Response to Submissions

State Significant Development Application - SSD-5700-2012

Block 4S, Central Park

Student Accommodation and Ground Floor Commercial Uses

Figure 1 – Separation distances between block 4N and 4S

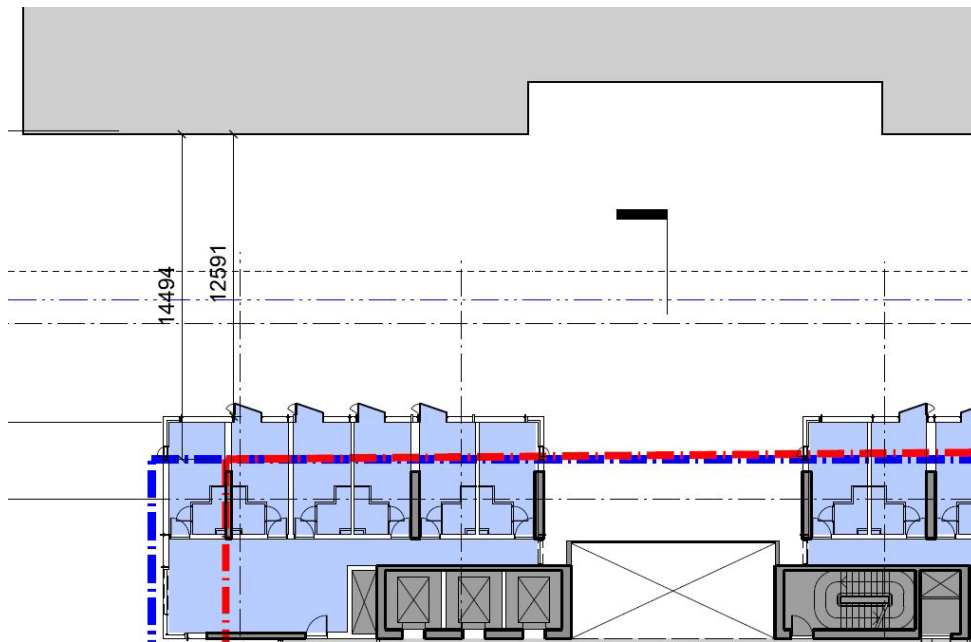
The DPI has requested consideration be given to increased separation between proposed buildings on Blocks 4N and 4S. This would respond to the separation of the previously linked buildings and the two distinct separate land uses proposed (commercial and residential). The Department considers that this could provide the following opportunities and respond to the separation of the previously linked buildings and the two distinct separate land uses proposed (commercial and residential)

- provide a high quality pedestrian link into the site from Abercrombie Street;
- reduce the appearance of bulk of the buildings when viewed from Abercrombie Street and within the site;
- increase opportunities to provide solar access to units within Block 4S; and
- Improve visual privacy to residents of Block 4S, allowing for improved residential amenity through a reduction on the reliance on privacy glass.

The proposed separation between Block 4N and Block 4S is largely established by way of the existing approved Concept Plan. The proposed separation design of the northern elevation of Block 4S and the public domain and landscape treatment provide a clear separation between these two buildings, whilst providing a high quality pedestrian link from Abercrombie Street into Central Park.

Due to the proximity of Block 4N and size of the approved envelope, along with the orientation of the building, a greater separation distance would have a negligible impact on improving the solar access afforded to the northern elevation of Block 4S. The proposed separation distance from Block 4N to the north is illustrated at on the revised architectural plans (drawing 5774 **Appendix A**) as 12.591m shown in **Figure 1**.

Figure 2 – Revised window treatment

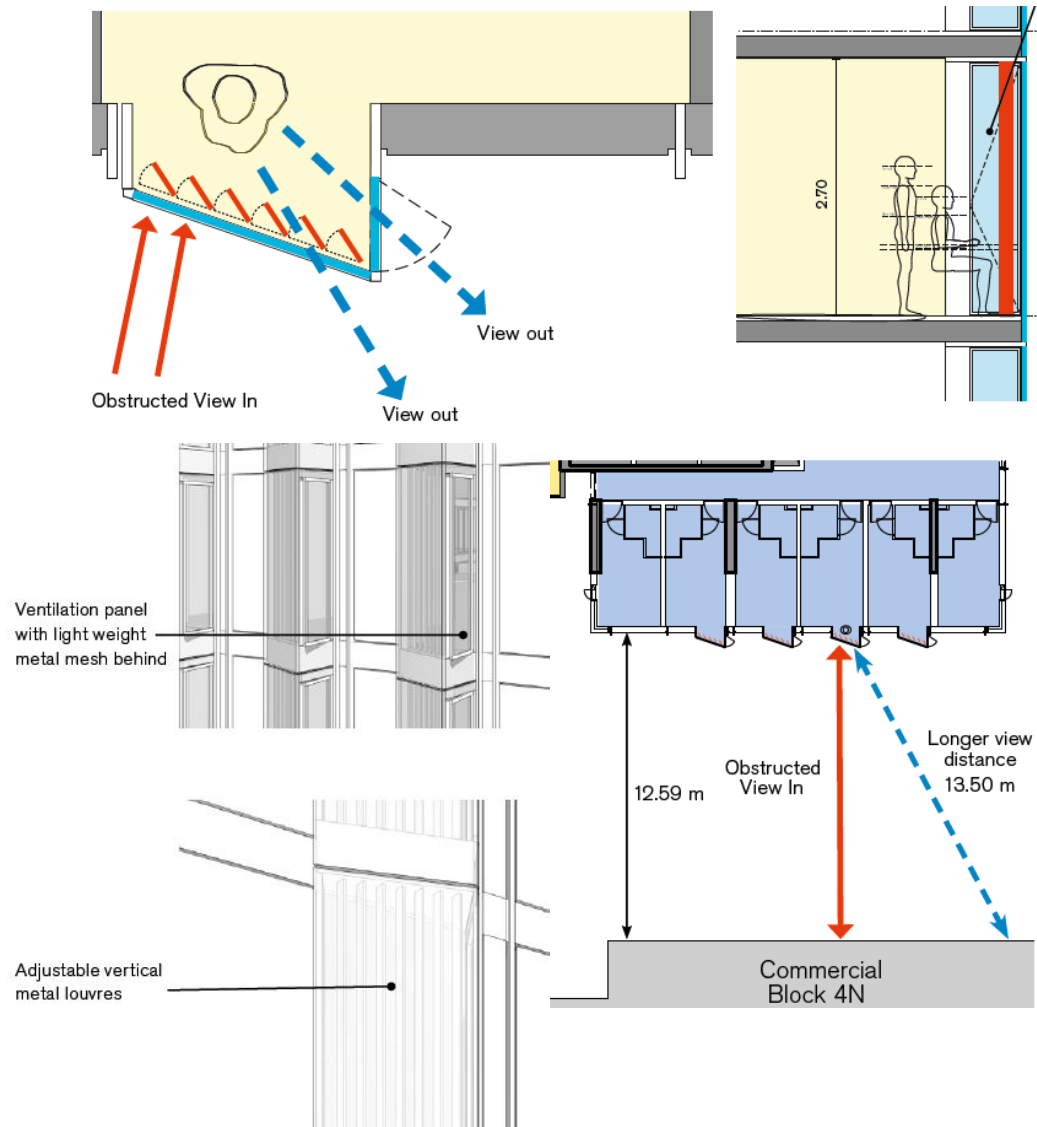
The DPI has raised concern over the proximity of the proposed building on Block 4N (12.5m), and the distance between facing habitable room windows on the internal building facades of the proposed building (12.7m) with regard to the potential privacy issued. Concern is raised in relation to the proposed reliance on privacy glass to those units to address this, and the resulting reduced amenity to residents. It is considered that internal window treatments could be adopted to address potential solar gain to units however; further consideration should be given to addressing potential privacy issues without adverse impacts on resident amenity

Given the separation distance between these two building, the northern elevation of Block 4S has been carefully designed (see revised architectural plans at **Appendix A** and additional diagrams at **Appendix B**) to provide aspect and privacy and to remove the reliance on privacy glass. The revised treatment of these elevations includes the following

- Removal of the existing privacy glass and replacement with vision (clear) glazing
- Installation of adjustable vertical metal louvers within the apartments
- Maintenance of the ventilation panel that also allows views out of the multi-bed apartment rooms
- Prevents the potential for direct overlooking between the commercial and residential uses.
- Allows for the penetration of sunlight between the louvres

As shown below in **Figure 2**, the proposed design will mitigate any direct overlooking whilst providing high levels of internal amenity to residents.

The proposed privacy blinds/louvers will be operable to provide occupants control over the penetration of light and privacy as desired.

Figure 3 – Datum line and pedestrian scale (datum line indicated by red dashed line)

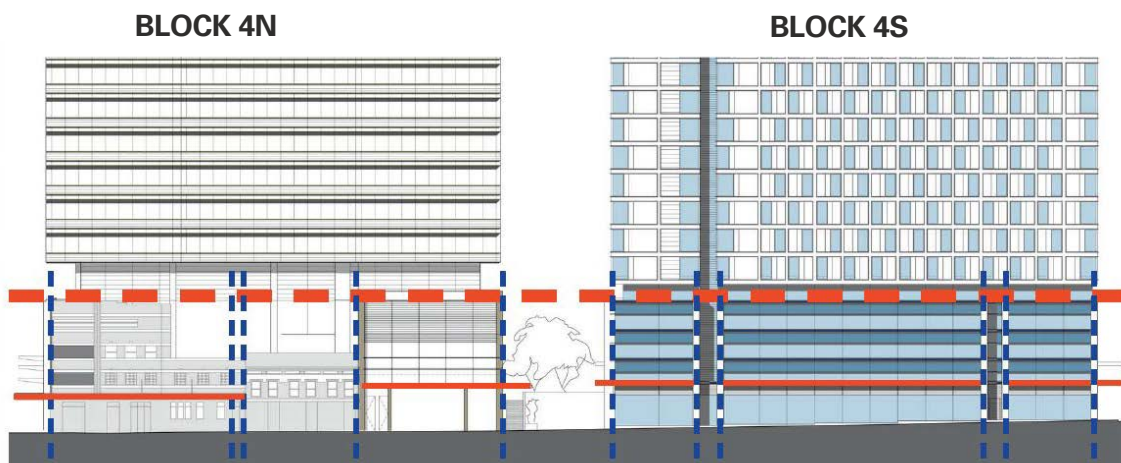
The DPI have identified a concern over the lack of building articulation which they consider would assist in reducing the appearance of bulk of the building's east and west elevations.

As detailed in the Urban Design Report the datum line (as established by the Concept Plan) has been used to establish a 'neck' zone above the podium, which respect the scale of the heritage buildings at the corner of Broadway and Abercrombie Street. Above the podium at level 3, the facade is recessed which reinforces the pedestrian scale of the building and lower level activation to Abercrombie street, as well as Irving Street. This can be seen in the perspectives and montages provided as part of the EIS and as annotated at **Appendix B**.

Figure 3 below has been taken from the urban Design Report and indicated the Datum line (red dashed line) established by the Concept Plan. The Datum line was included within Concept Plan aimed at reinforcing the pedestrian scale of future development on the site. The proposal is consistent with this element, incorporating horizontal elements of the adjoining heritage hotel, which was used in part to establish the original Datum.

Figure 5 – Internal facade design and privacy treatment

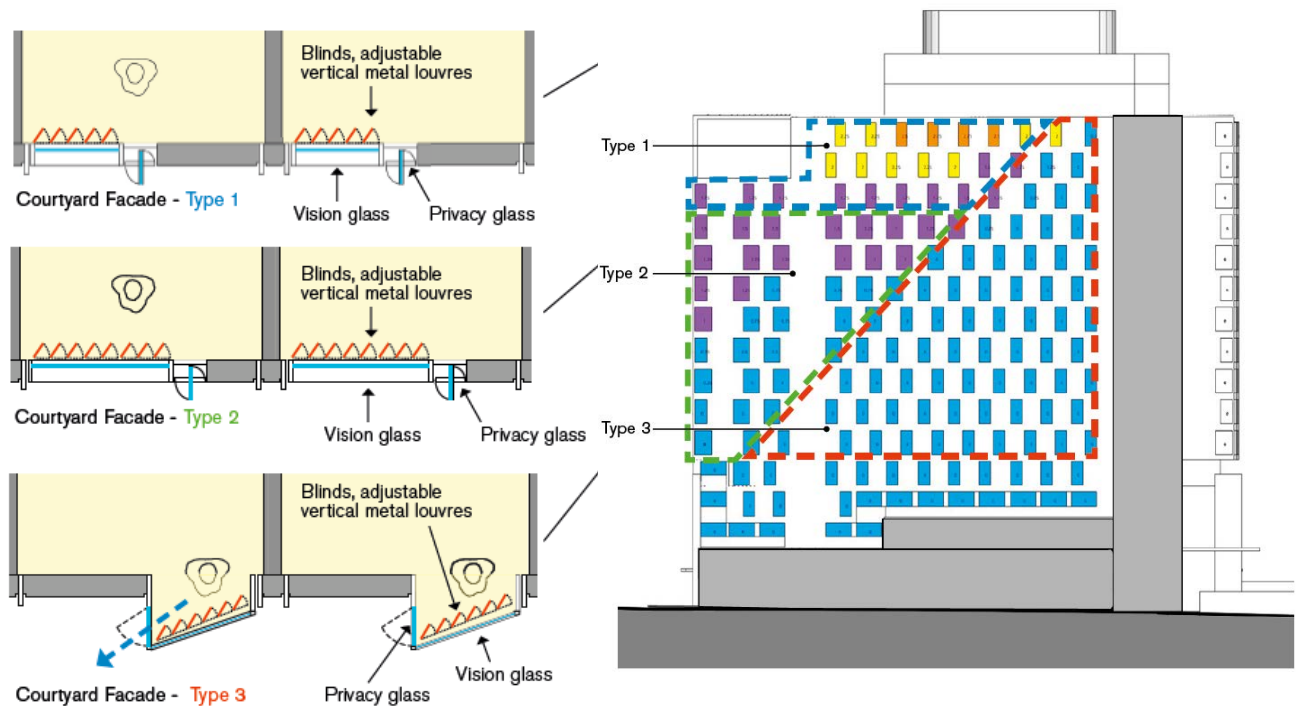
Further information is requested as to the justification of the proposed arrangement for courtyard facing studios in terms of having either bay windows with privacy glass or fixed vision glass.

As discussed previously, the design of the northern facade has been reviewed in response to the submission from the DPI. The review of the design and treatment of the northern elevation in particular has removed the strong reliance on privacy glass, and in its place, internal window treatment has been considered including internal blinds and louvers.

As shown below in **Figure 4**, the internal facade have been treated with three alternative designs that consider privacy, and solar access. The upper levels have

- Type 1 facades are located on the upper levels of the courtyard. This portion of the façade is subject to the greatest solar exposure and has the same vision glass dimensions as used on the East and West facades.

- Type 2 facades receive less direct sunlight and the opportunity to increase the size of the vision glass has been embraced to admit more daylight to these studios.

- Type 3 facades are located in the deepest portions of the courtyard that are the most shaded. Units in these areas are provided with bay windows to open their view to the south where the courtyard is not enclosed.

Figure 8 – Irving Street Activation with retail.

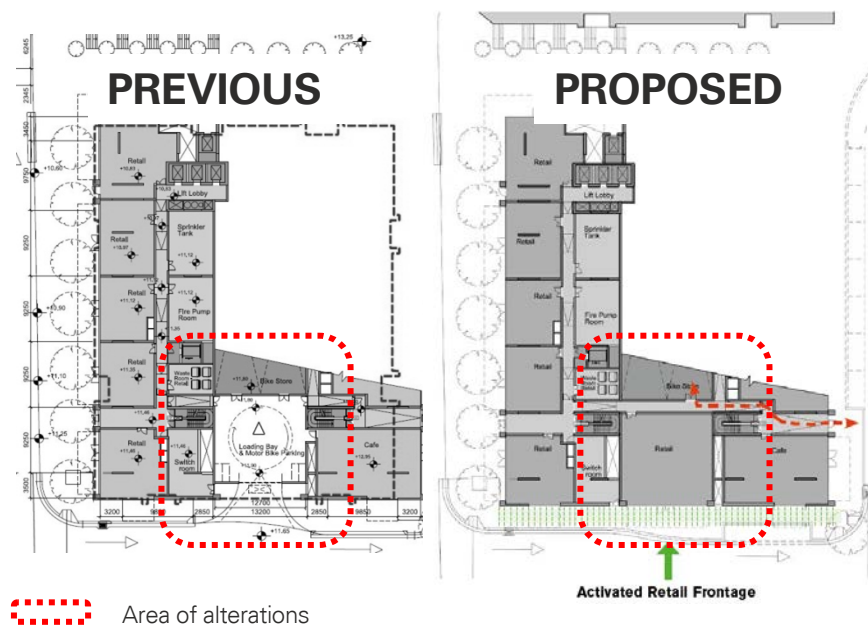
The DPI have requested the design of the pedestrian link between Blocks 4N and 4S be reviewed for opportunities to maximise the quality and efficiency of the pedestrian link, given the importance of the through link as a main pedestrian thoroughfare, as noted in the EIS's Safety Management Strategy and other supporting documents. Measures could include maximising opportunities for pedestrian trafficable area and the provision of street furniture.

The previously located temporary loading dock at the southern elevation of the site has been removed. The ground floor of this elevation has been replaced with retail tenancies as shown on the revised architectural plans at **Appendix A** and **Figure 8**.

The addition of retail to the southern facade results in a far greater level activation to Irving Street and the entry to Central Park from Abercrombie Street, and increase in non residential by some 200sqm. The design allows for retail tenancies to be located on the corner and are afforded dual street frontage. Awnings have also been added to the southern elevation, providing weather pedestrians to pedestrians entering and exiting the site. Giving the sites location opposite the public park, the southern elevation is envisaged to be a highly used pedestrian thoroughfare with pedestrians accessing the public park from Abercrombie Street and areas further west.

In addition, the change in the design reduces the number of truck/service vehicles at this intersection, and the potential amenity and noise impacts associated with the loading/service area use.
